ADDENDUM #1
TO CONB 2023-01
Neptune Beach Activity Center Porch and Exterior Finishes

February 9, 2023

NEW PORCH
NEPTUNE BEACH COMMUNITY CENTER
NEPTUNE BEACH, FLORIDA

SHEET
A3

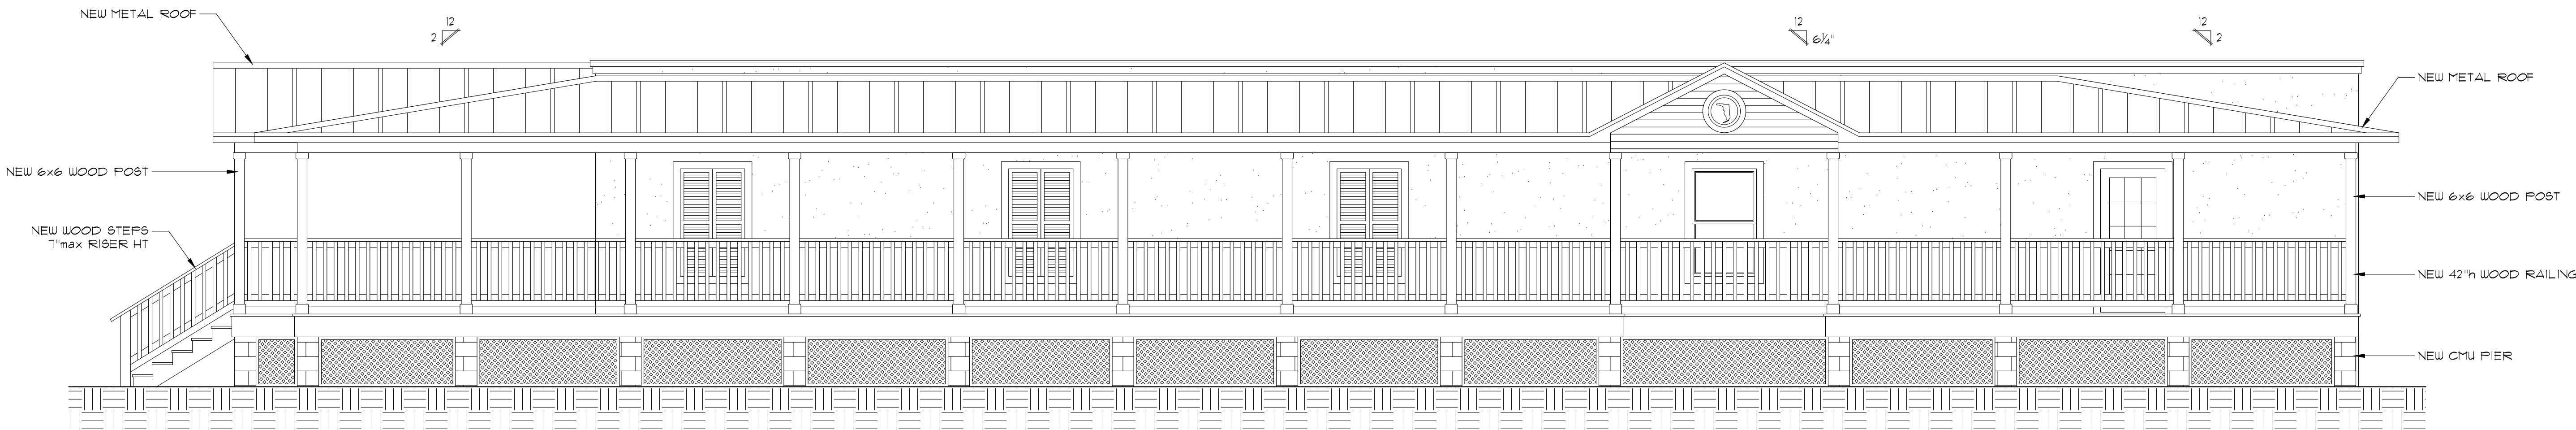
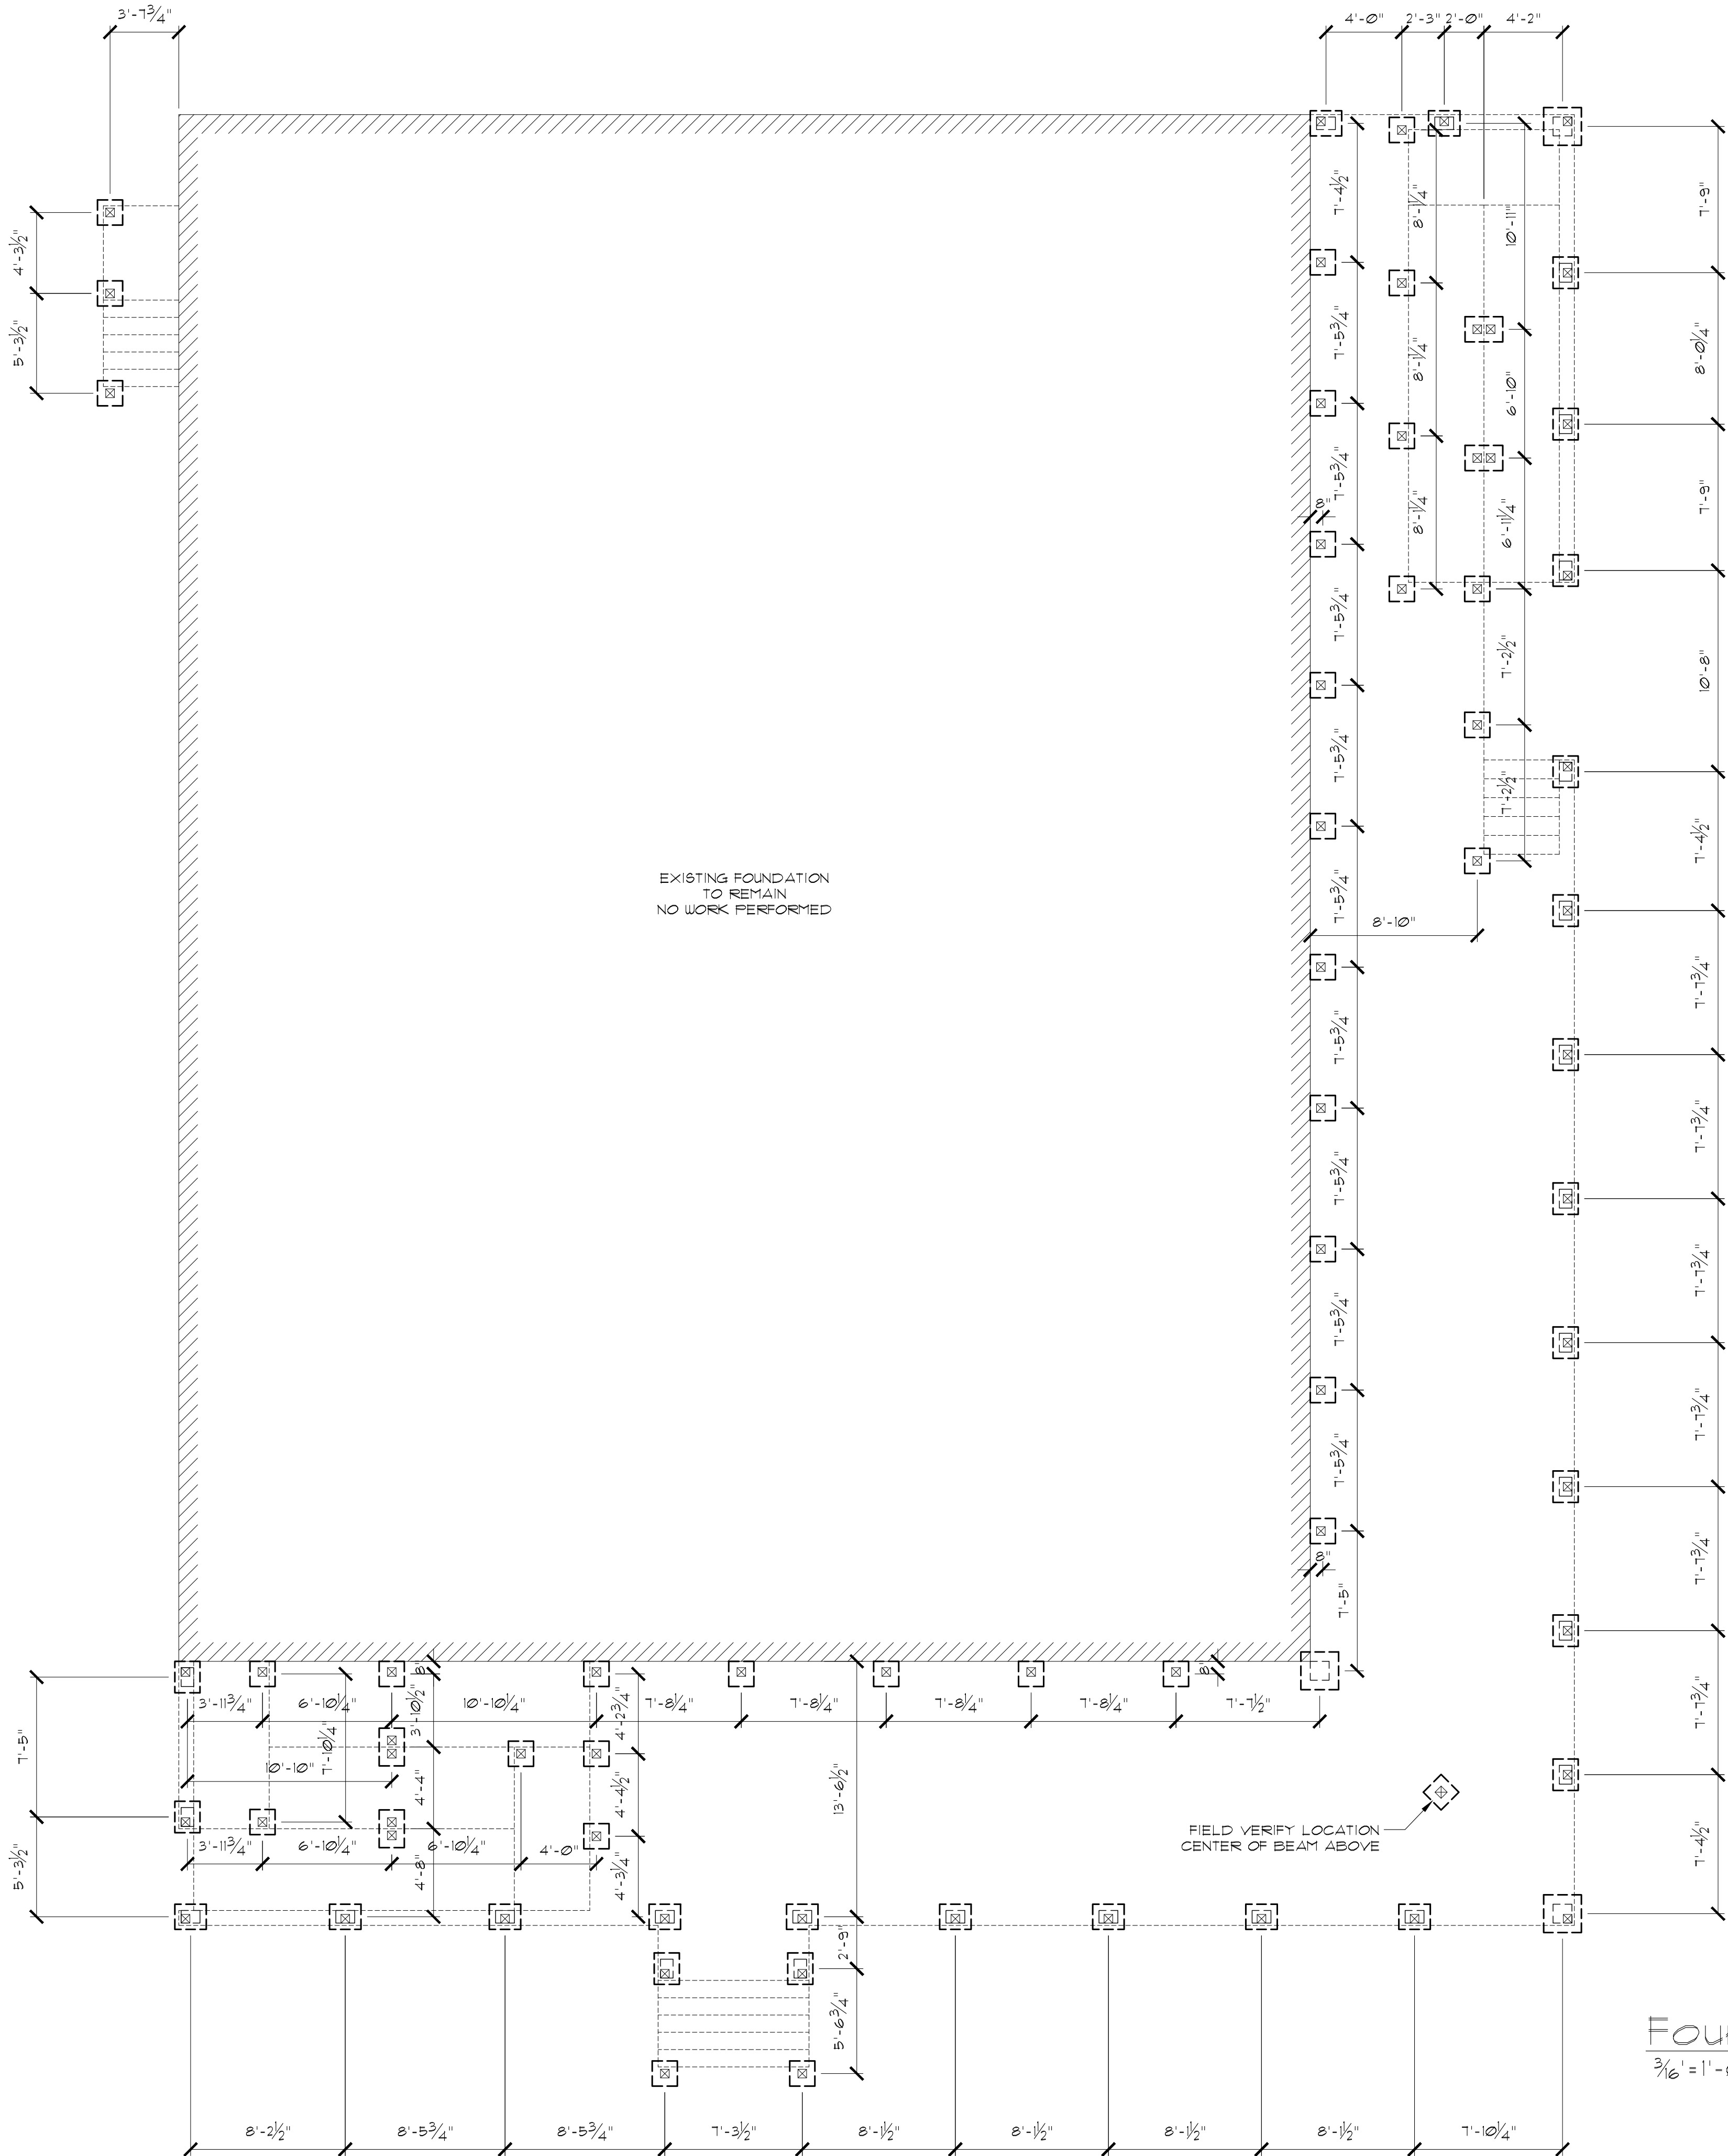
1. Per A3 on the elevations page what kind of screen is to be used in between the cmu piers?
2. Per A3 on the elevations page the roof is called out to be metal, but on the section A7 it shows the roof to be asphalt shingles please identify?

1. Per A3 on the elevations page-the architect/design team suggested LATTICE between the cmu piers;
2. Per A3 on elevations page -the entire roof is METAL;
3. Ceiling inside the building is drop throughout;
4. The fans and fixtures will be bought and installed by the owner/City;
5. The Procurement Contract Times needs to be May 30, 2023, as funding sources have placed time restrictions on the monies. This can be renegotiated with the funder should

SHEET
A8

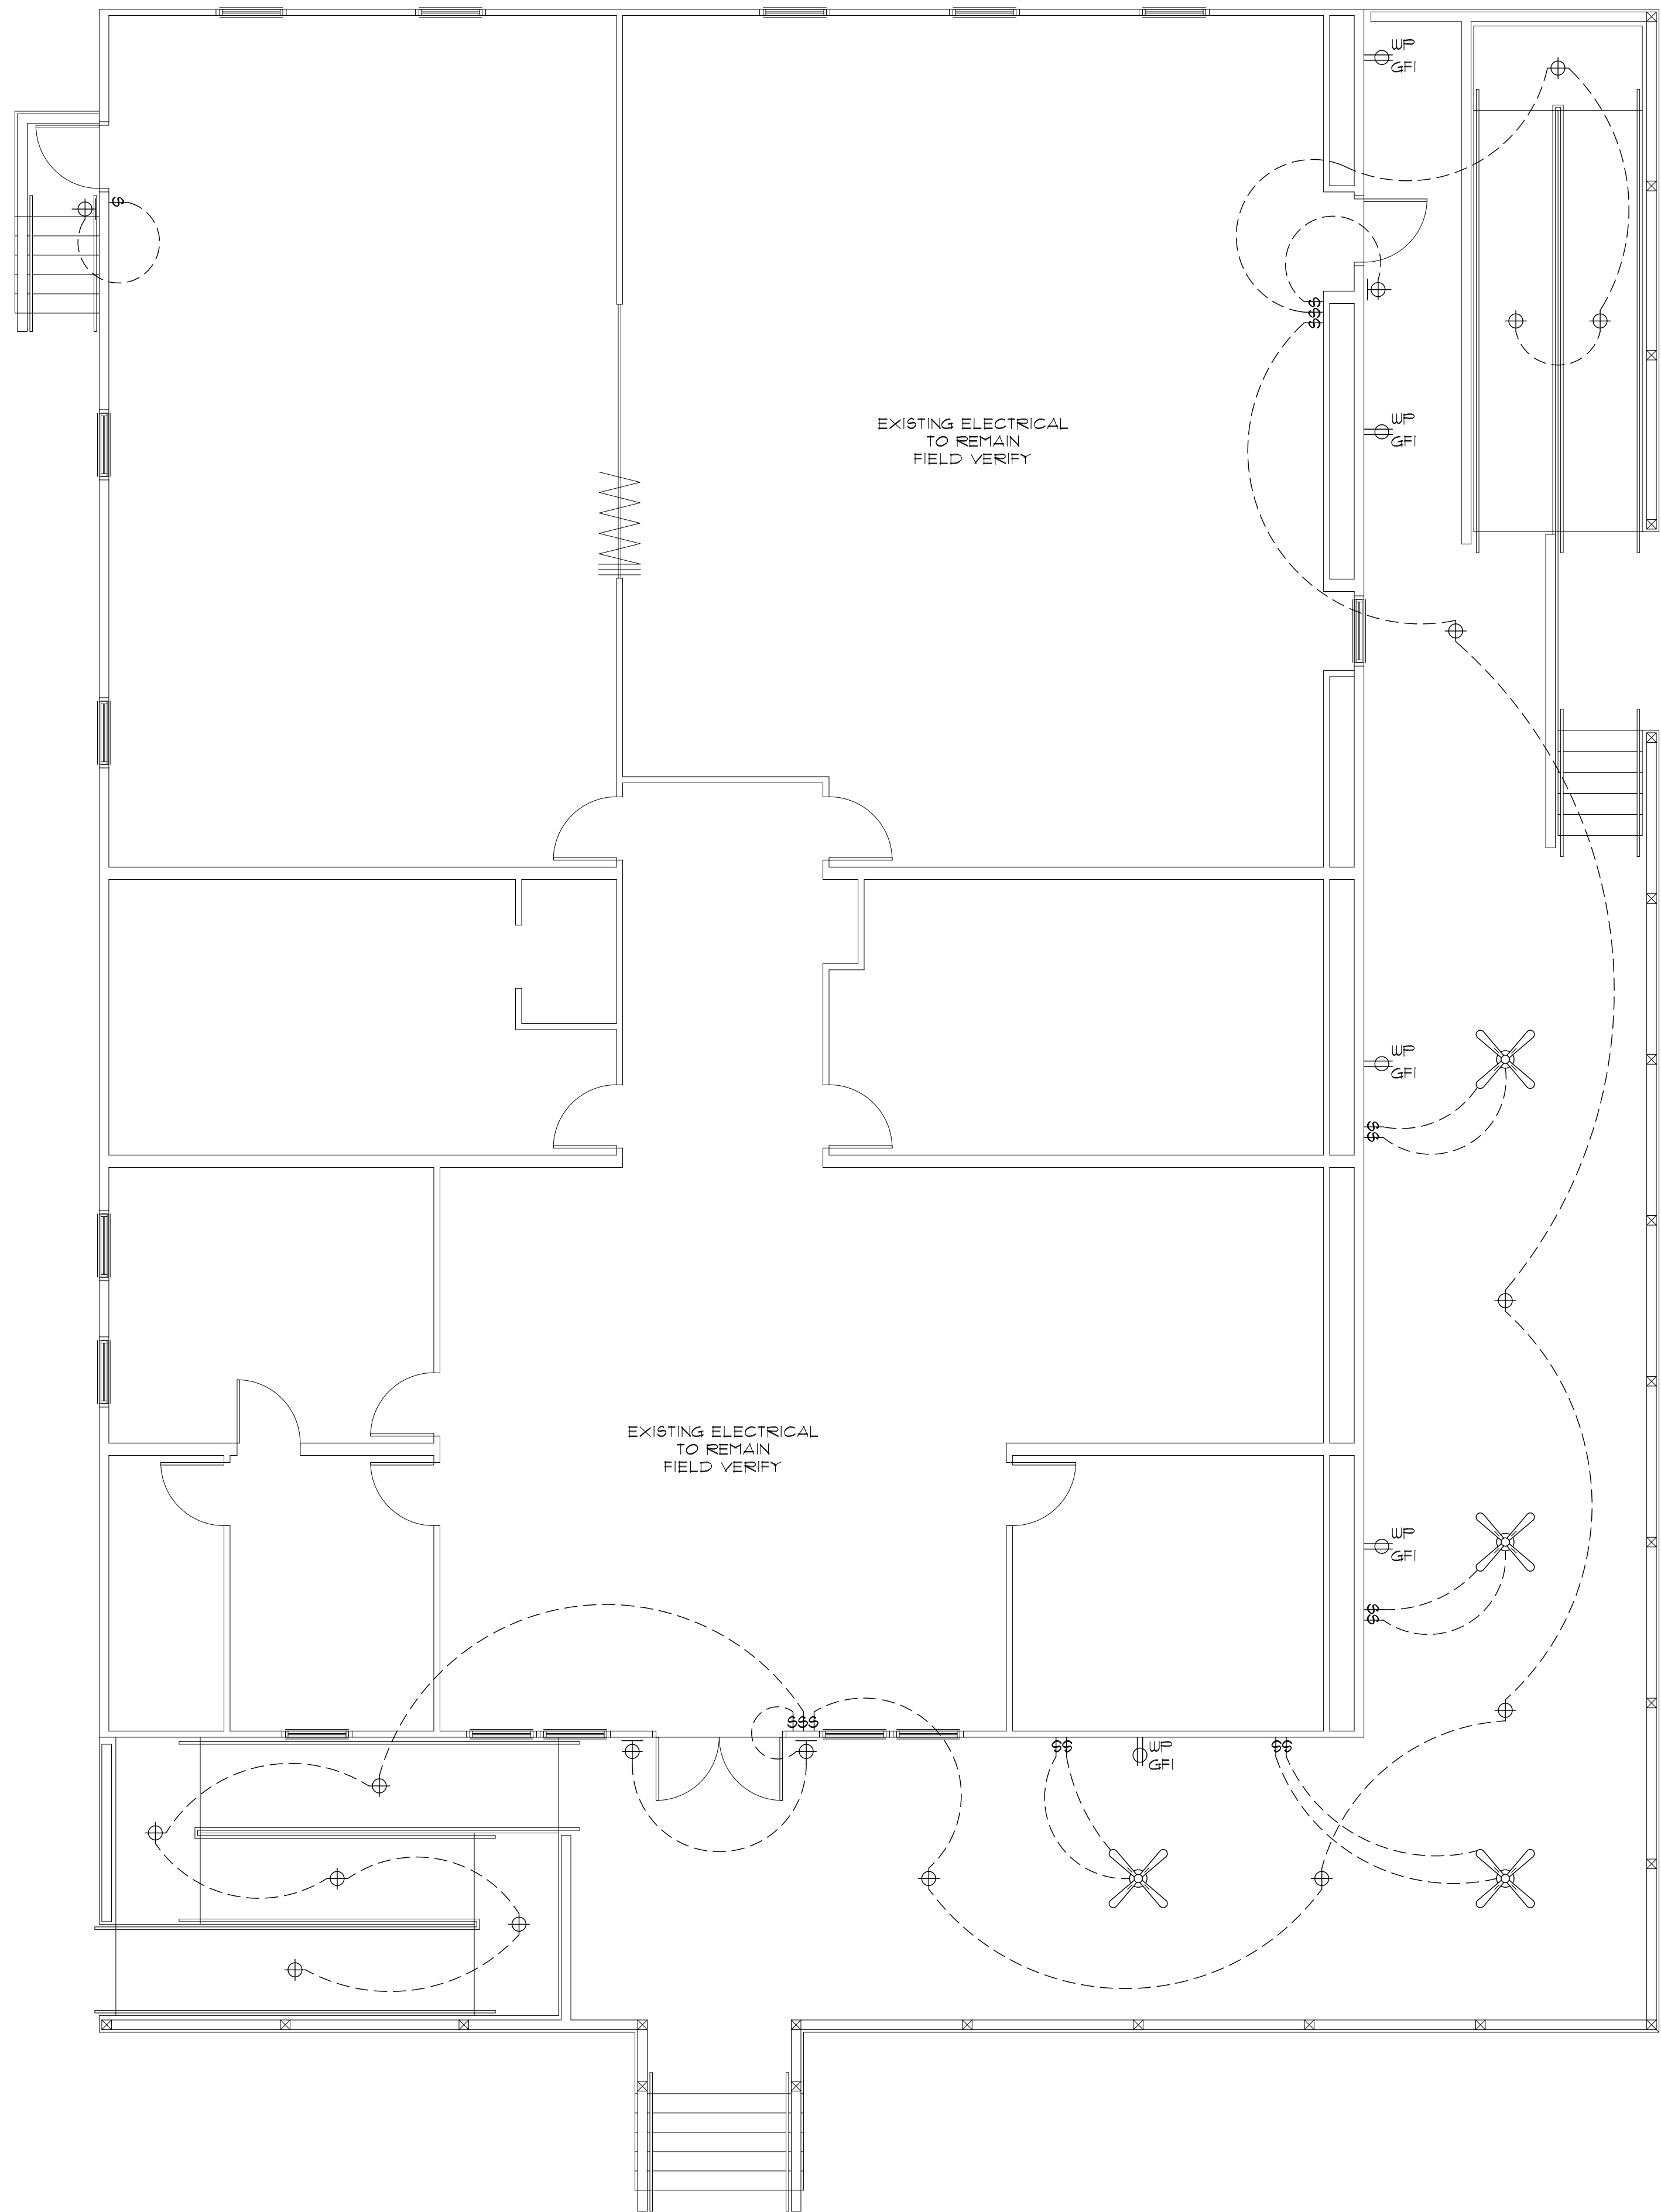
3. What is the ceiling type in the electrical room where the existing panel is located?
4. The fan and fixtures are stated to be selected by owner on A8, Will they be purchased by the owner?
